## BALLARD YARDS

SDCI #3030168

## DESIGN RECOMMENDATION

JANUARY 14, 2019

## 8 SITE PLANNING/ 54TH STREET ROW

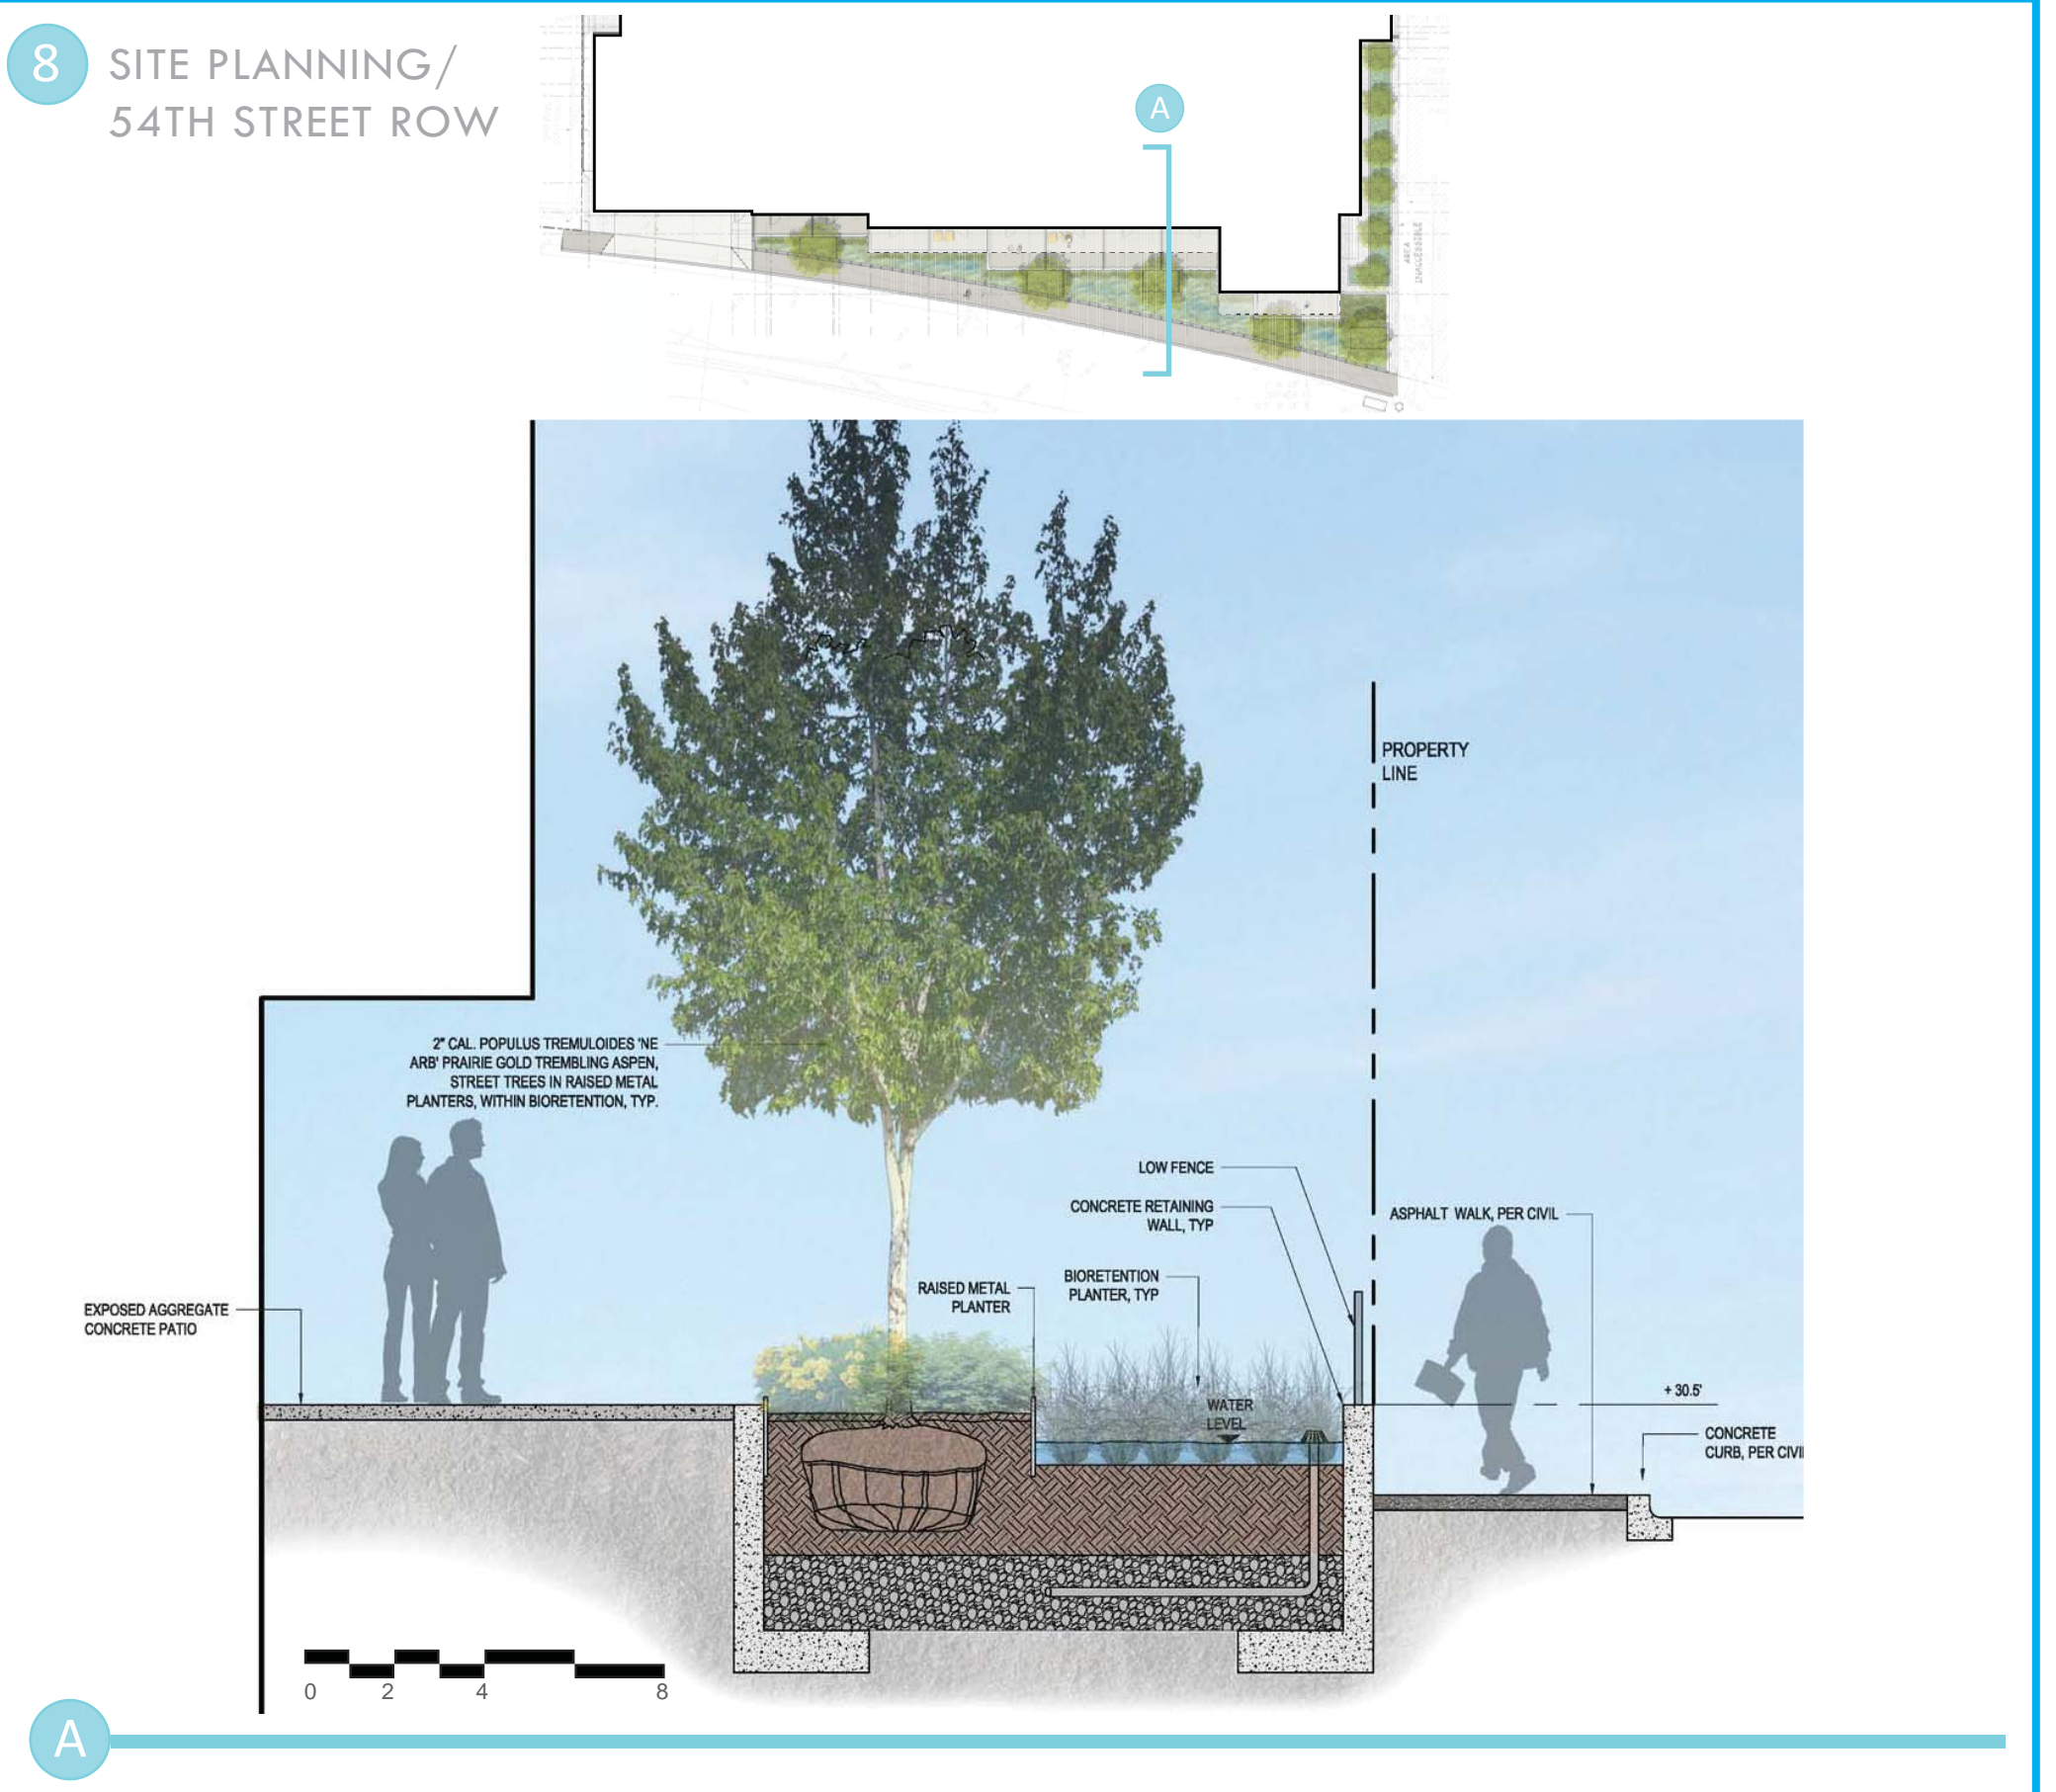
The Board was disappointed not to see more complete site drawings and encouraged the applicant to provide complete documentation for the next meeting, including clear indicators as to why the proposed design is the best solution, both at Market and 54th. (DC4-D, CS3-B, CS3-B-1, PL1-B, PL2)

A site plan was included in the EDG packet, but was regrettably not included as one of the slides in the presentation. This will be sure to be included during the Recommendation meeting presentation.

For additional clarity, sections have been cut through the retail court and along 54th Street to highlight in detail how the building and landscape design interacts with the adjacent grade developments.
